**ISSUE:** Certificate of Appropriateness for new construction

**APPLICANT:** City of Alexandria and Washington Metropolitan Area Transit Authority (WMATA)

**LOCATION:** Old and Historic Alexandria District  
2500 Potomac Greens Drive (2405, 2501, 3701 Potomac Avenue, 3251 Potomac Avenue [Parcel ID 016.04-01-01], 700 Carpenter Road, 1702 and 1880 Potomac Greens Drive) 2901 Potomac Avenue (2405, 2501, 3701 Potomac Avenue, 3251 Potomac Avenue [Parcel ID 016.04-01-01], 700 Carpenter Road, 1702 and 1880 Potomac Greens Drive)

The BAR has been reviewing this enormous project through an iterative, cumulative process. The applicant has requested approval of the following three items at this hearing. The remaining items will be brought forward on December 18, or whenever they are ready. Item numbers below reference a spreadsheet that the applicant has used at the past several hearings and is included in the linked staff report of October 16, 2019.

3 HANDRAIL BASE DETAIL - DESIGN OPTION  
13-A-502 SCALE: 3" = 1'-0"

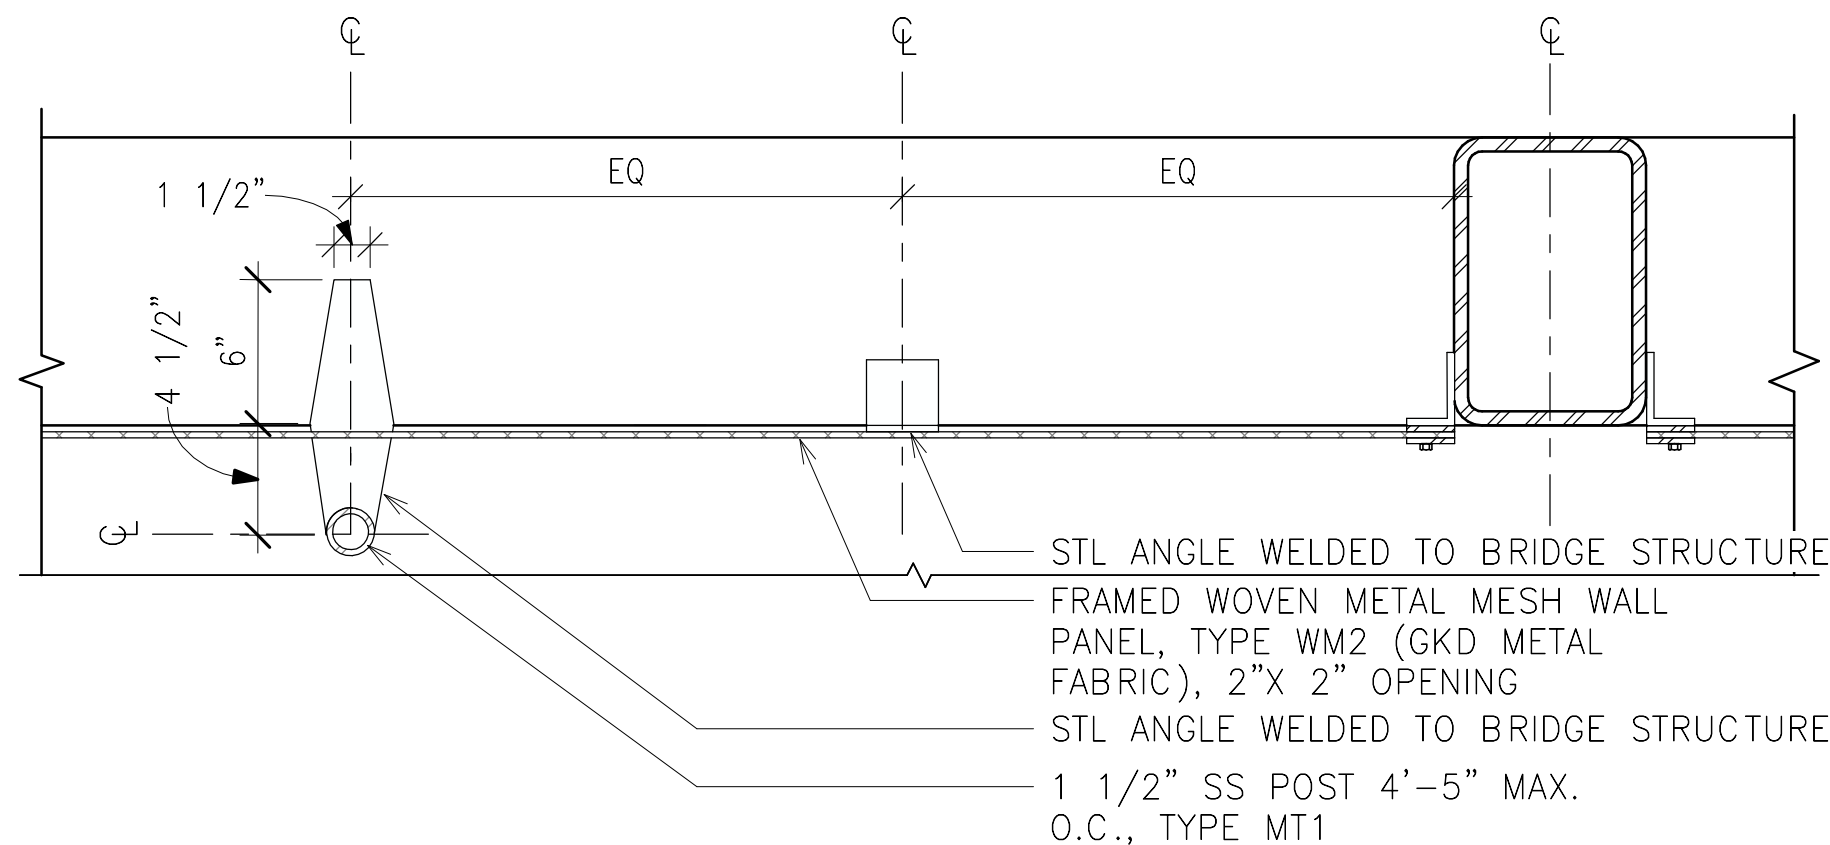
At the previous hearing, the BAR approved simplified, curved rafters for the pedestrian bridges and the installation of the woven metal mesh “fence” on the inside of the truss, with a request to restudy the number of handrails required by code and how they will attach to the floor and/or truss – the design goal of the BAR being to visually simplify the construction details, similar to other recent WMATA stations. The design/build team has submitted engineering calculations to the City and WMATA to confirm that the 2” x 2” stainless steel woven metal mesh held by a perimeter frame secured to the truss will itself meet the code requirements for a guard rail, so that one of the two previously shown horizontal handrails may be eliminated. The handrail stanchions at the vertical truss chord locations have also been eliminated and a simple bracket, shown in detail 4/13-A-502, is being used at all vertical chords and on handrail supports inside the station. This eliminates one-third of the vertical stanchions in the walkway. In addition, the base of the stanchions supporting the handrail have been angled so that they may be welded to the bottom chord of the truss for constructability and maintenance reasons. This is similar to the stanchion base used at the Silver Line Metro station that the BAR saw at a previous hearing. Staff recommends approval of the revised handrail design.

# Lighting Render Updates

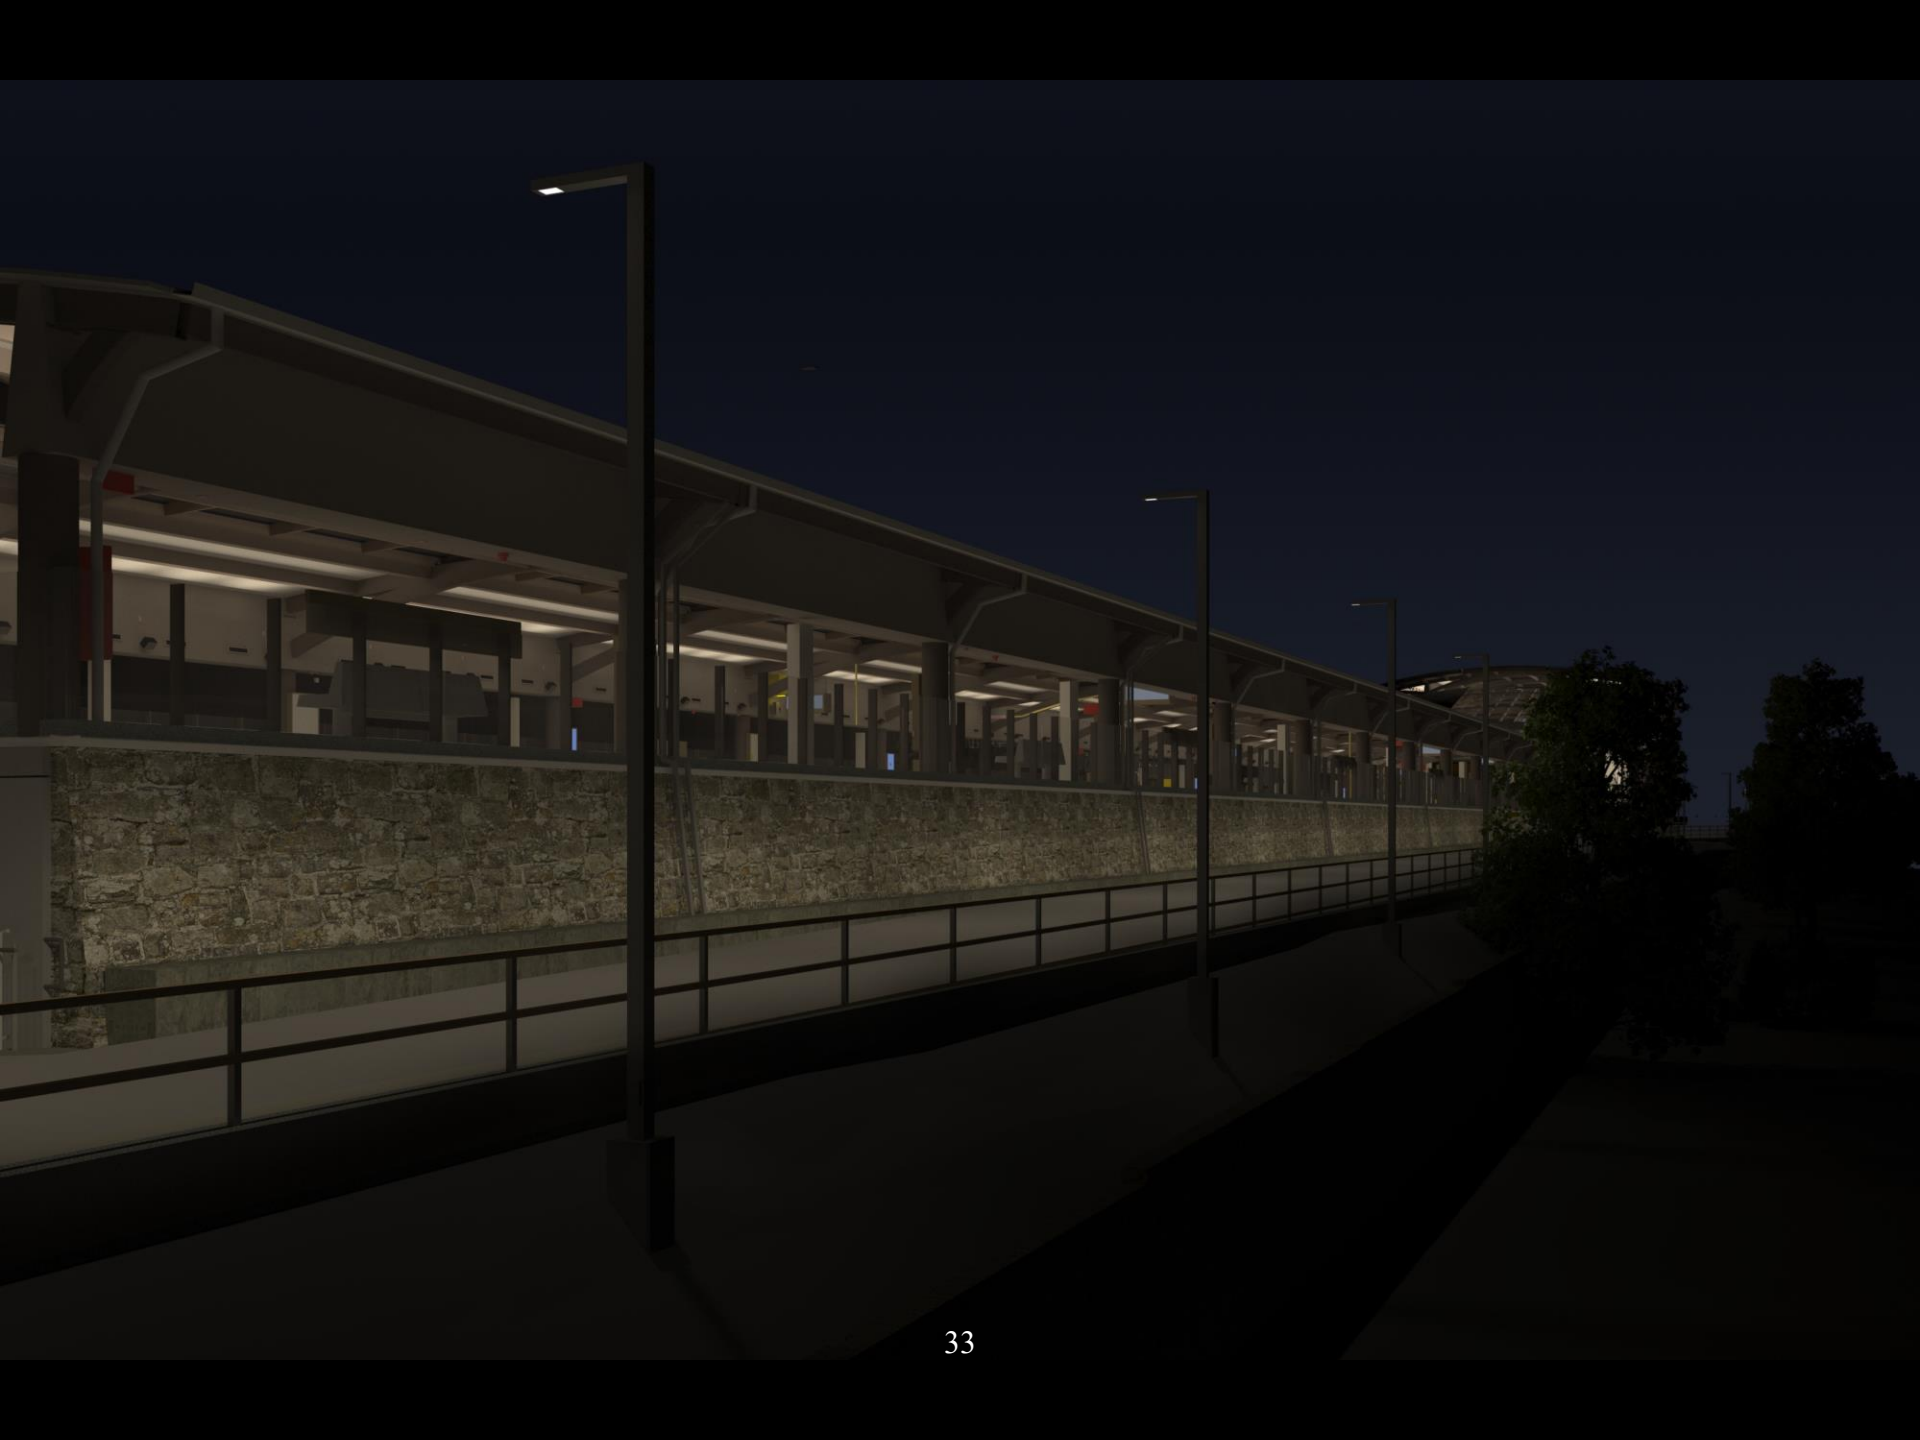
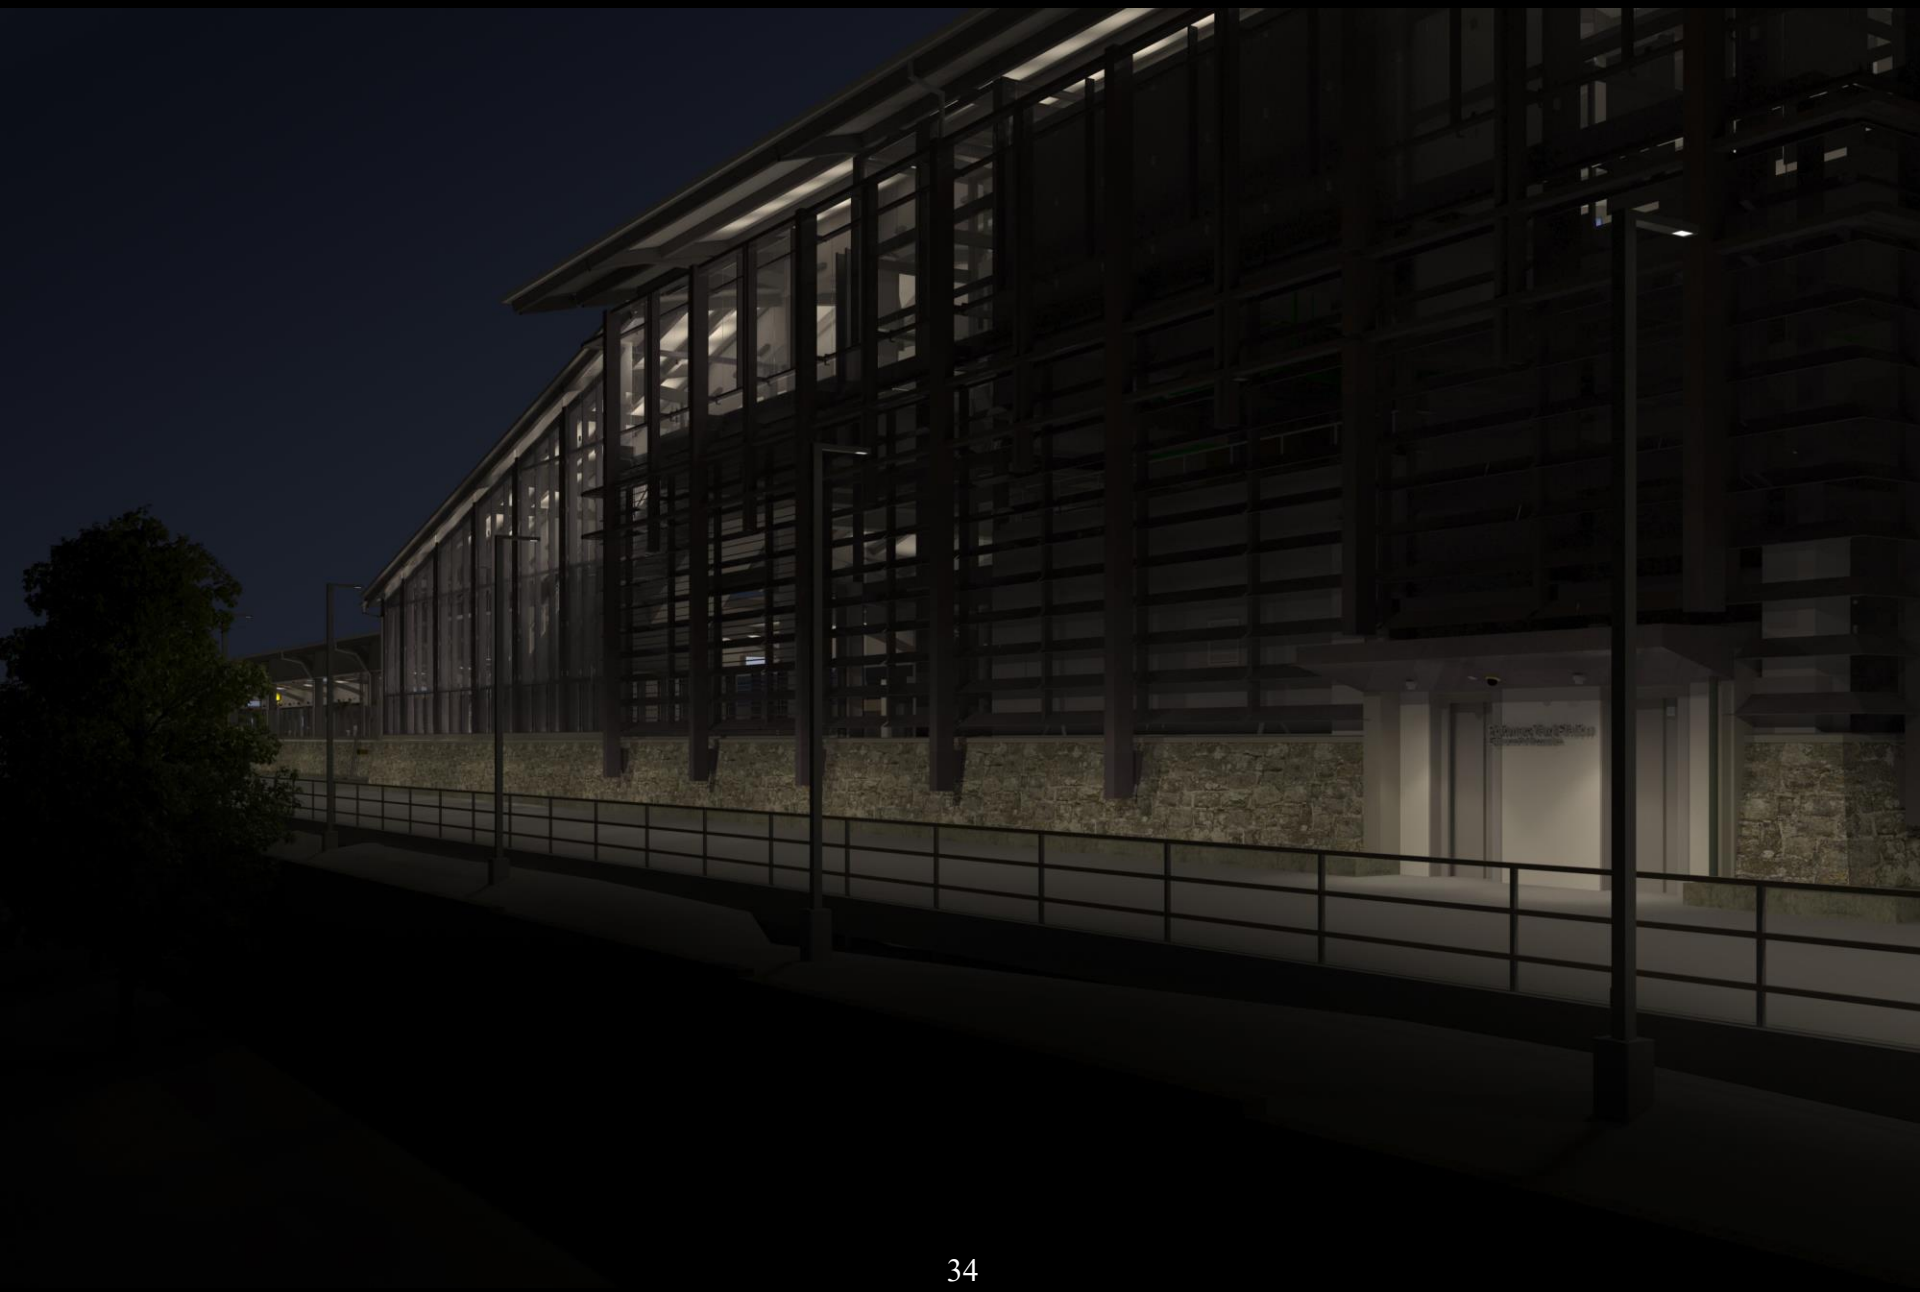
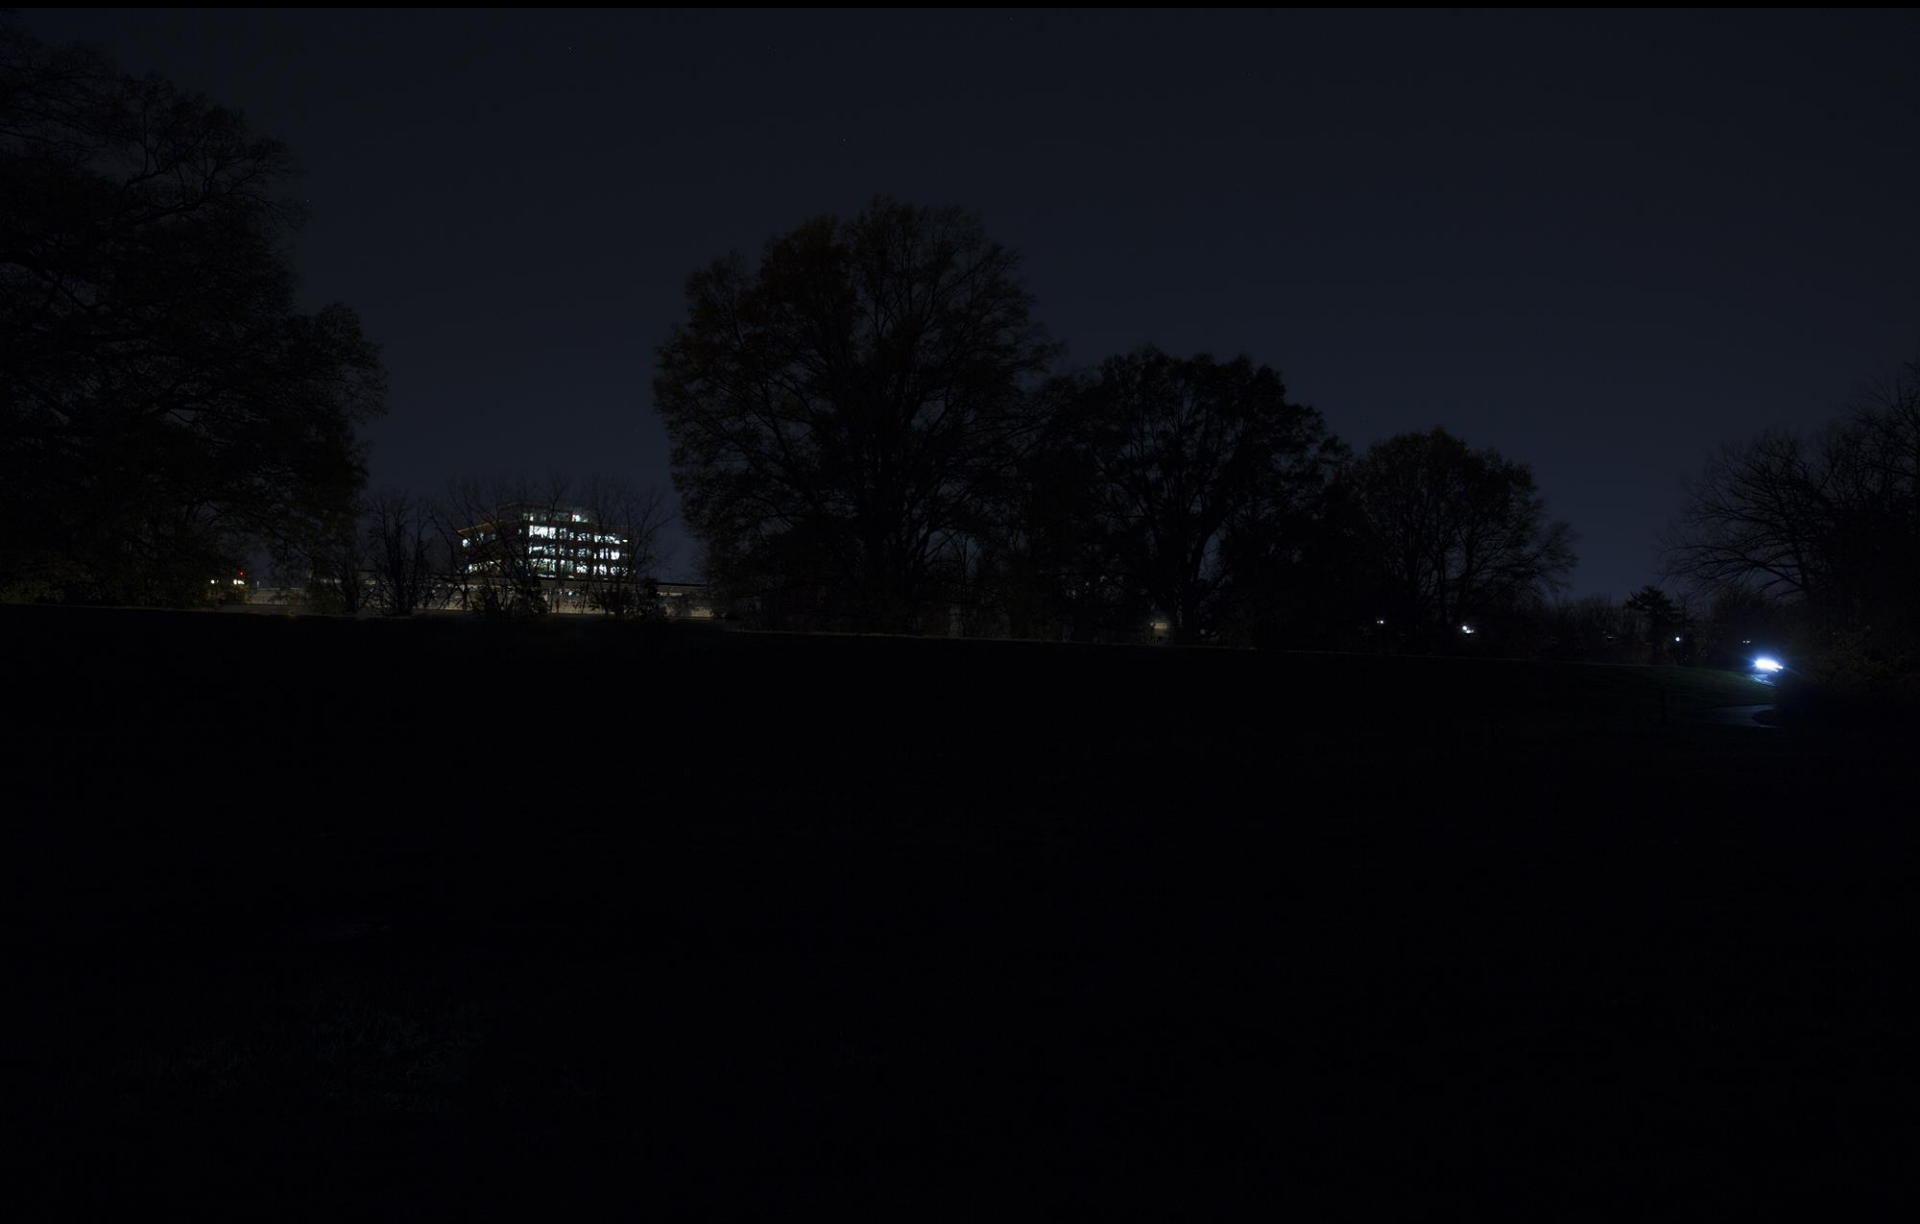
The applicant has revised their lighting renderings of the overall station to show as accurately as possible the conditions as viewed from the GW Parkway – with and without vegetation. The station lighting engineering photometrics have been reviewed by WMATA to confirm minimum safety standards. The photometric plans have been revised and labeled to show that the mezzanine and platform have the same number of lumens at the floor level and that the mezzanine will not be brighter, as it appeared in some of the previous illustrations.
